RE: 1416 Espejo St NE
Grading and Drainage Plan
Engineer's Stamp Date: 03/09/2026
Hydrology File: J20D043
Case # HYDR-2026-00089

Based upon the information provided in your submittal received 03/10/2026, the Grading and Drainage Plan **is not approved** for Grading Permit and Building Permit. The following comments need to be addressed for approval of the above referenced project.

GRADING AND DRAINAGE PLAN

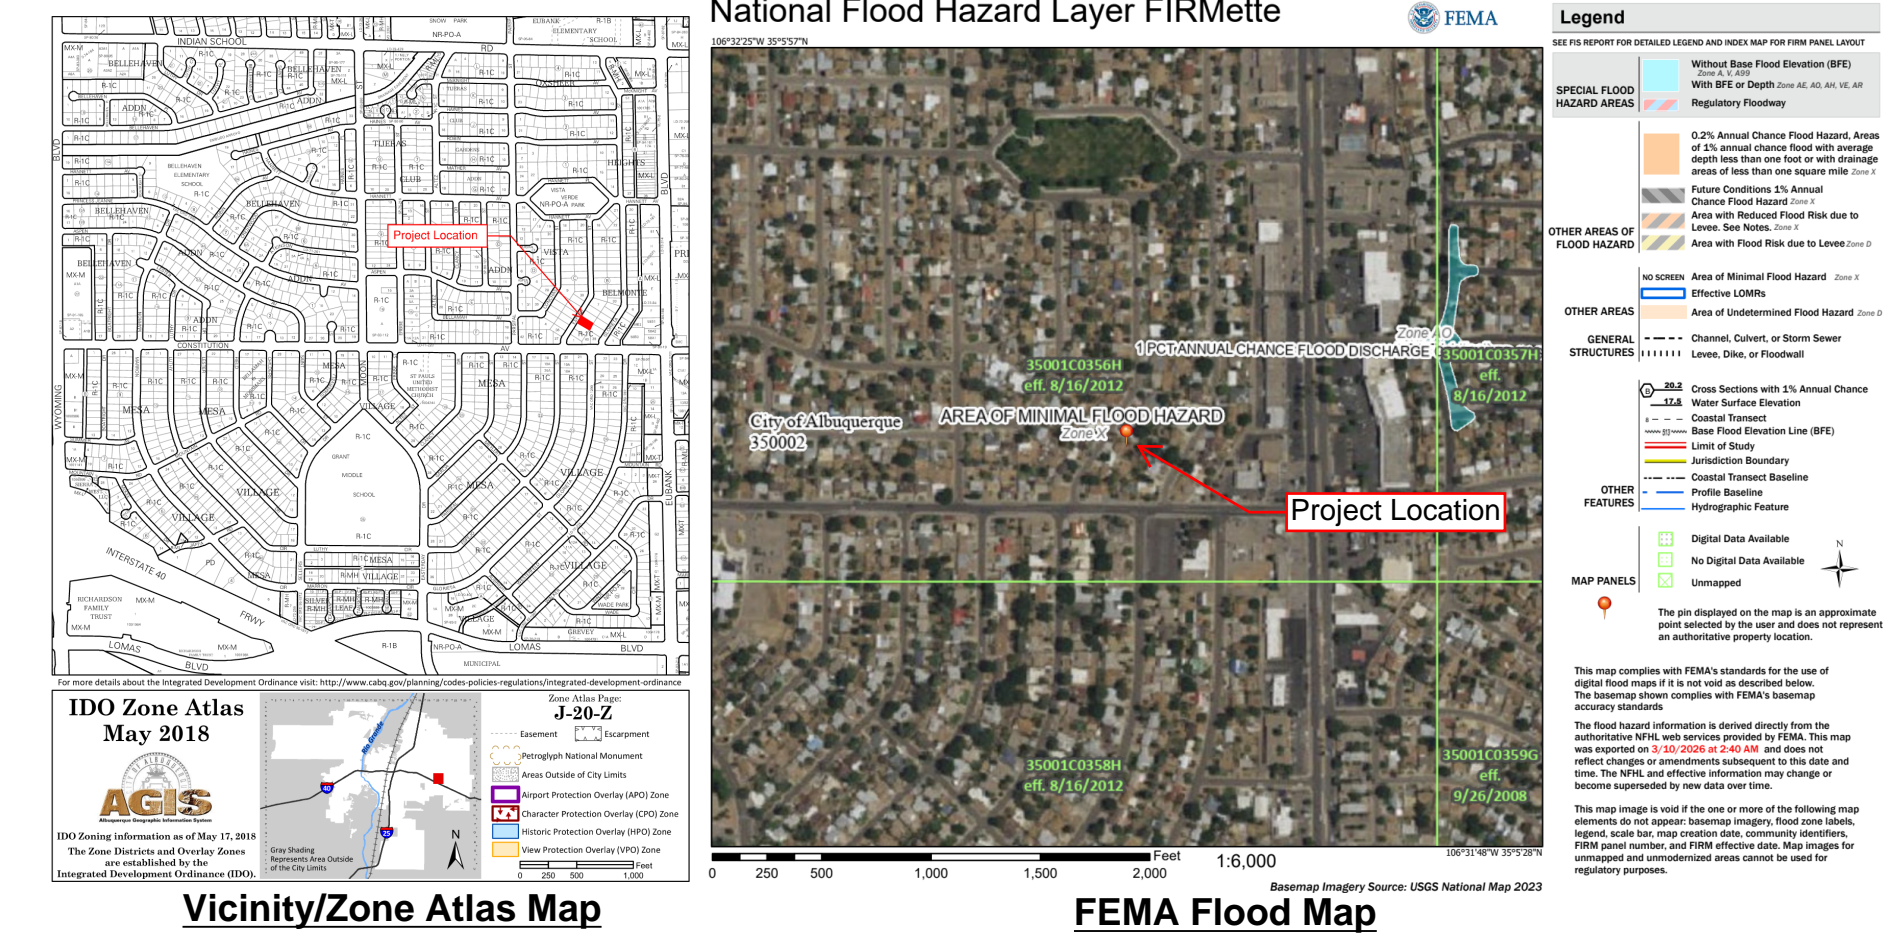
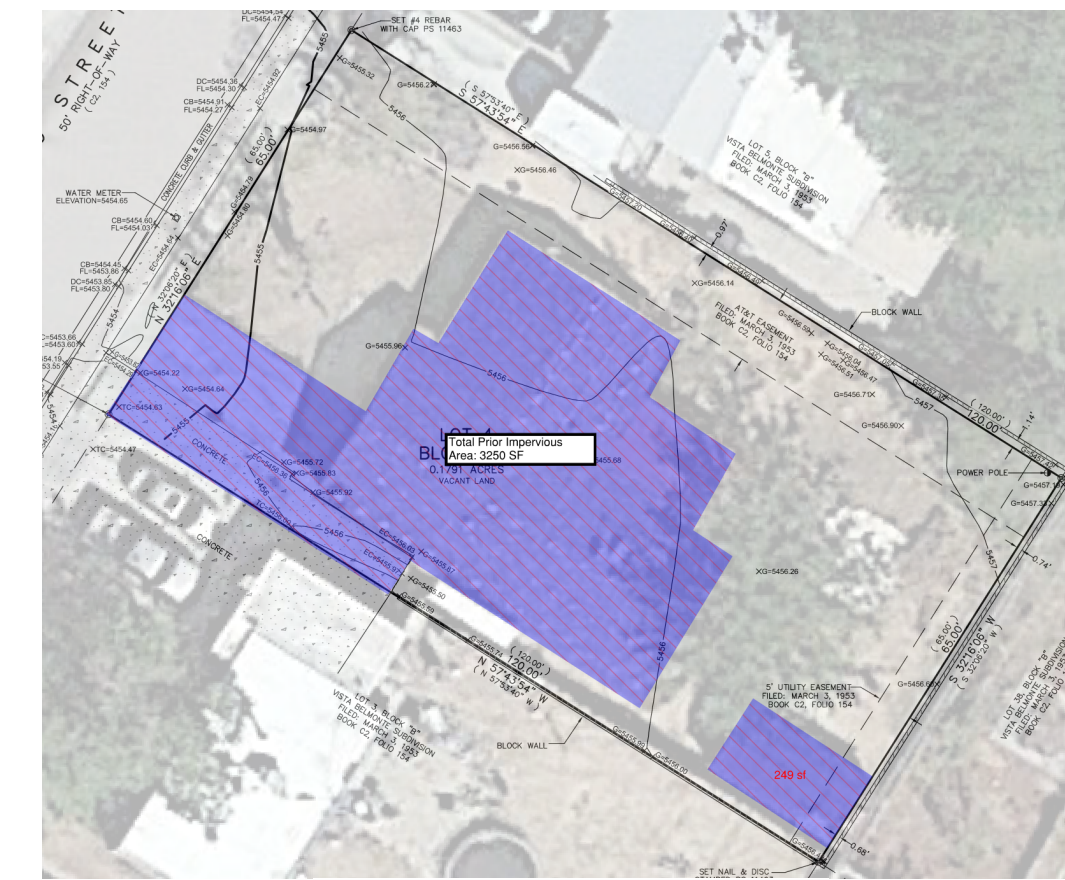
1. Please number the ponds and include a label on each with the SWQV and elevation, the 100-year volume and elevation, the peak 100 year inflow and outflow, the spillway crest elevation, the spillway flow depth, and the dam top elevation.

2. Please show calculations of both existing and proposed conditions. See calculation example below:

3. Remove Note #3. A Pad Certification is not required for this site.
4. Change DTIS to Building Permit as the approval being sought.
